HISTORIC PRESERVATION BOARD

AGENDA

HISTORIC PRESERVATION BOARD MEETING

3. **COMMUNICATIONS AND REPORTS**
 4. **WORKSHOP - 5:00 PM**
 - i. Preliminary Review of Proposed Building Reconstruction and Exterior Alterations (2nd Workshop); 58 Fore Street (Building 12 of former Portland Company complex); Portland Foreside Development Company, Applicant.

Workshop 2 - West Elevation

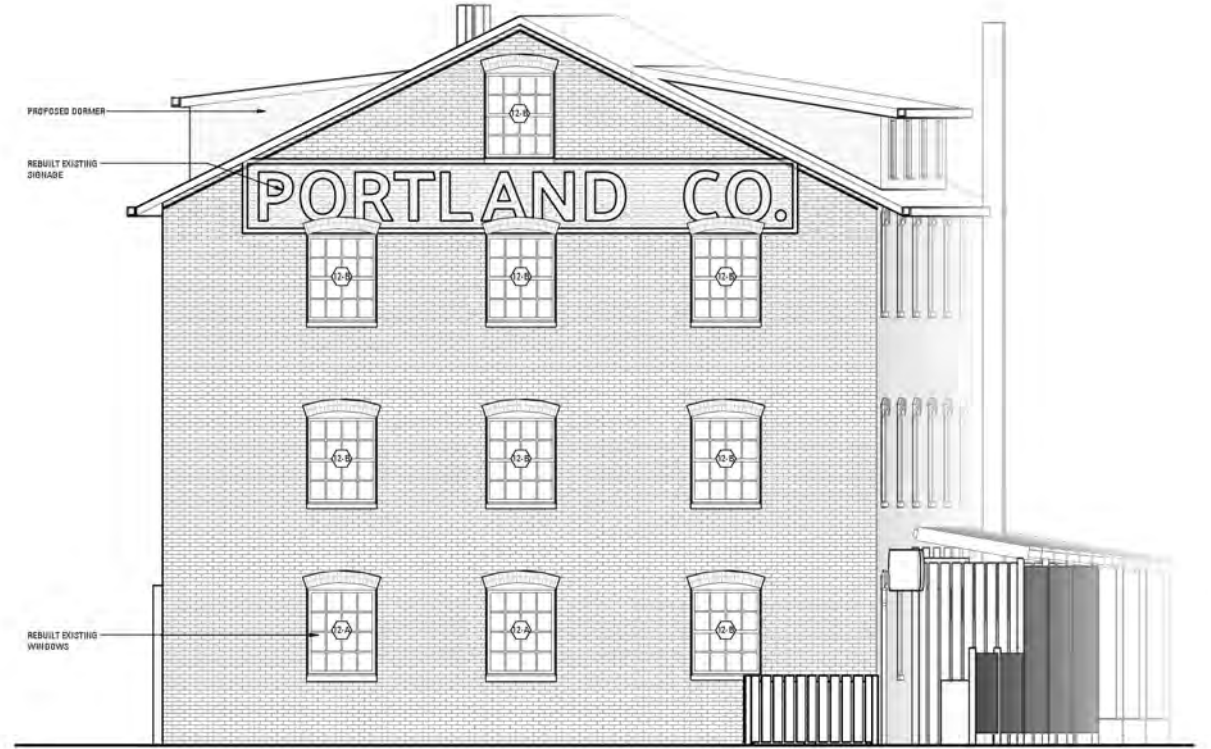
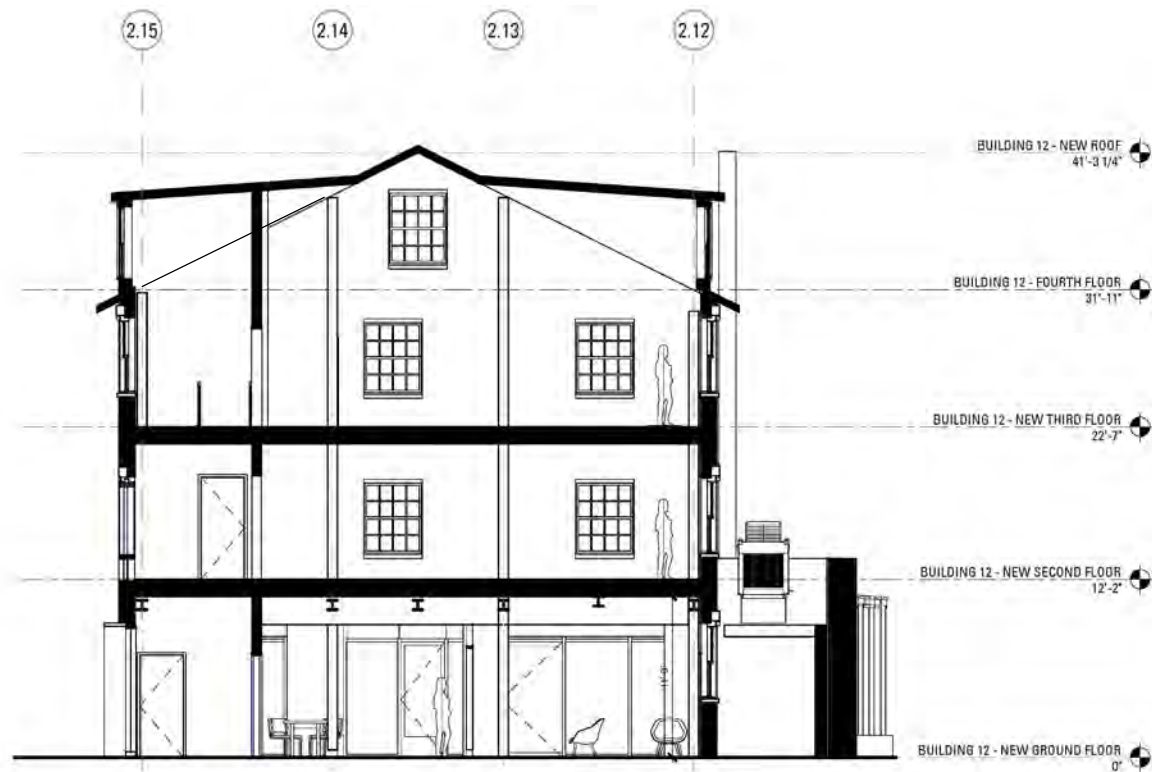
Based on this threshold consideration, Board members asked the project architect to explore modified or alternative design solutions that would reduce to the greatest extent possible both the number and visual impact of added elements. In particular, the Board found the cumulative effect of the proposed alterations and additions to the south elevation to be visually distracting and incompatible with the building’s character-defining simplicity of form and architectural expression. They noted that the proposal treated the south elevation as a secondary, or “back of house” elevation. Board members made clear that they considered the south elevation to be a primary elevation and its sensitive treatment critical given its high visibility from the Eastern Promenade Trail and the water.

Board members were mixed in their response to the proposed treatment for the north elevation where the building’s physical separation from Building 11 left a large void in the wall. While two members of the Board supported Mr. Moss’s general direction of providing a brick infill solution that resulted in a more solid, substantial wall with punched openings, other members questioned the rather conservative infill approach and expressed the view that the design solution did not make clear the “story” of this elevation. Several members favored an approach that would treat the large void as a single, architecturally consistent and clearly contemporary design expression. They noted that there was an opportunity to create a dialogue with Building 1 located immediately across the access drive, perhaps echoing the highly glazed character of its ground floor. The treatment of Building 12’s large void could be clearly contemporary in design but executed in a traditional industrial material palette.

As noted in the introduction, for each of the building elevations, the original proposal is shown next to the revised proposal. This is very helpful in quickly identifying the specific modifications made since the first workshop and assessing the impact of the changes.

Workshop 2 - Section

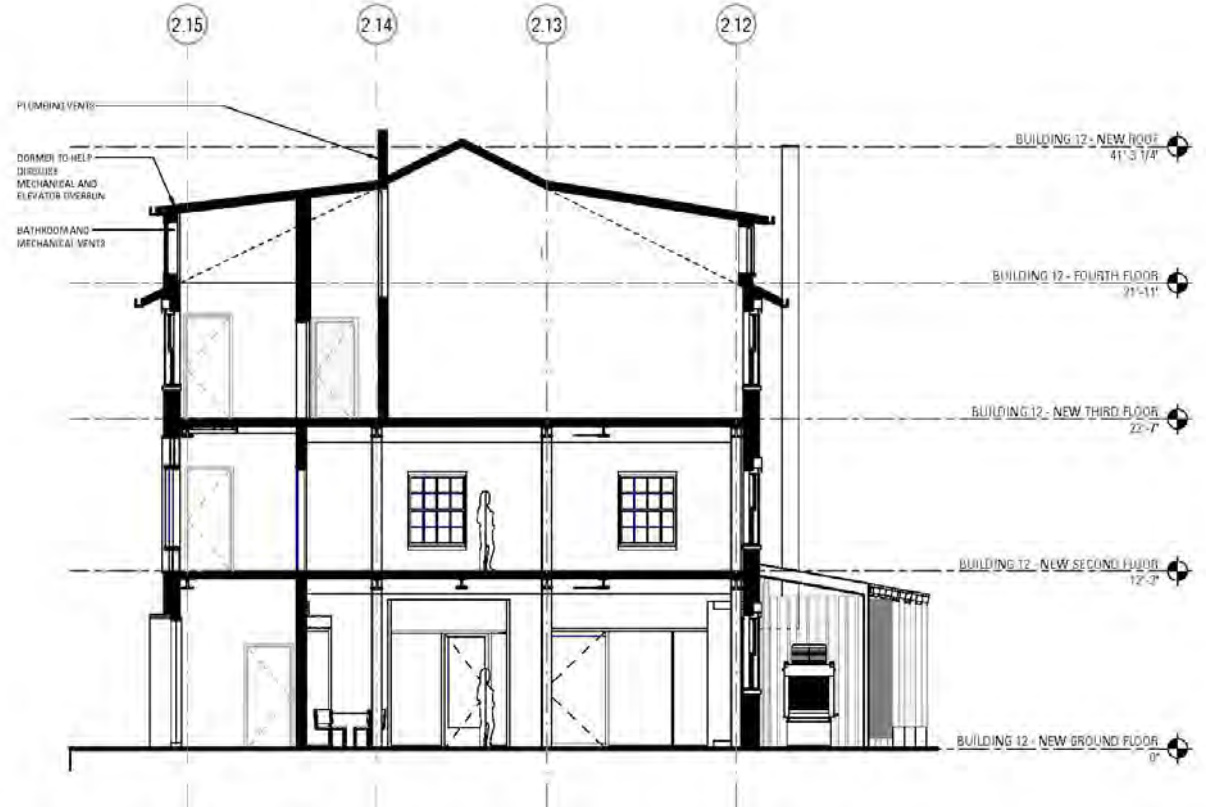
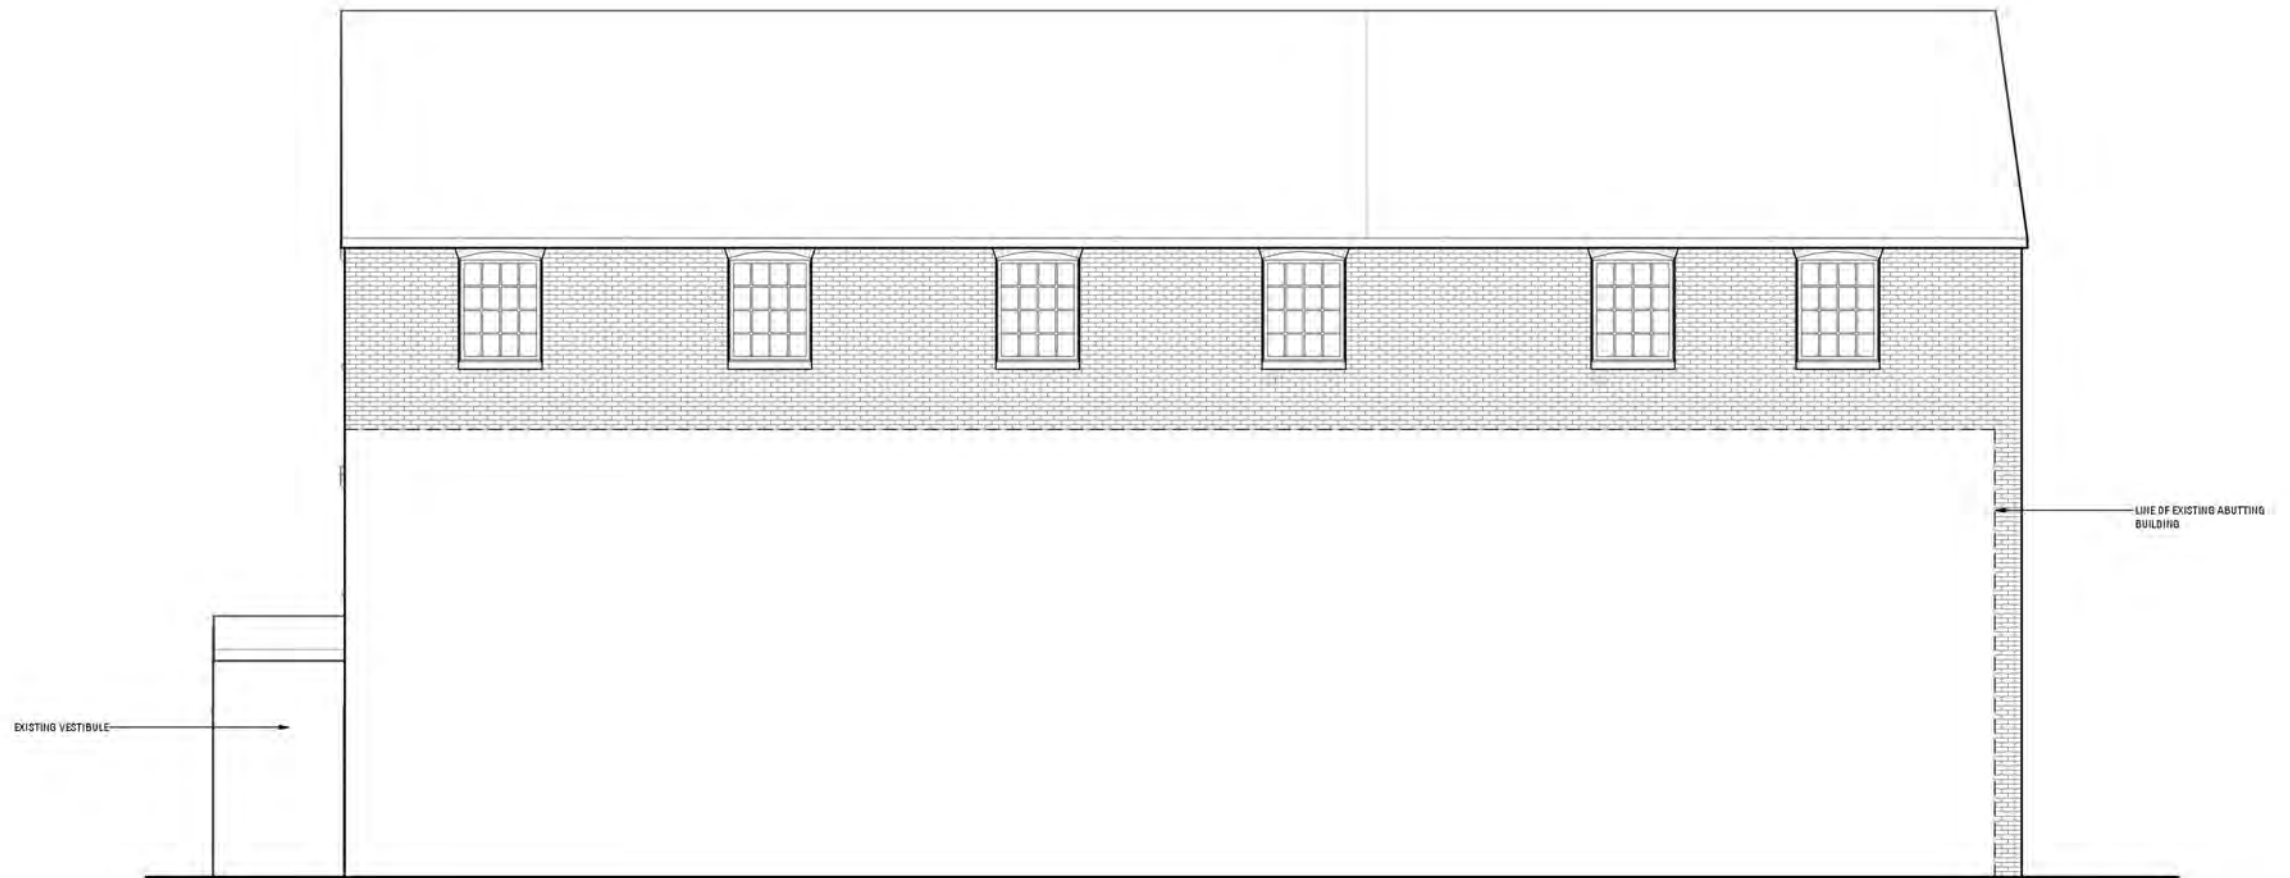
- Dormers: Members questioned the need for dormers, especially on the south-facing roof plane. While the dormer on the north-facing roof plane would serve a purpose in concealing the elevator vent and other mechanicals, the south-facing

dormer would only provide additional light for the residential unit on the third floor. The proposed size and roof pitch of the dormers was also questioned, as was the size and multi-lite character of the windows within the dormers. Members asked whether the overall width and profile of the dormer(s) could be reduced to make them more recessive and incidental to the existing building. Most members expressed the view that the south-facing dormer should be eliminated altogether.

- Both roof dormers are retained, but the width of the north-facing dormer is reduced. The roof pitch of both dormers is modified, the window or vent openings are smaller and the window sash are distinguished from the historic sash on the existing structure. Plumbing stacks are now shown above the north-facing dormer.
- On the north elevation, the new window openings within the infill area have been modified. The second-floor openings are taller with panels above and below the

Staff finds the north-facing dormer to be much improved in the revised proposal. The dormer is smaller, more recessive and clearly distinguished from the historic structure. Staff still questions the proposal to introduce a dormer on the south-facing roof plane, notwithstanding the changes to the roof pitch and windows. By eliminating the dormer, this important building elevation, particularly as viewed from a distance, will retain an essential aspect of its historic character: its simplicity and clarity of form.
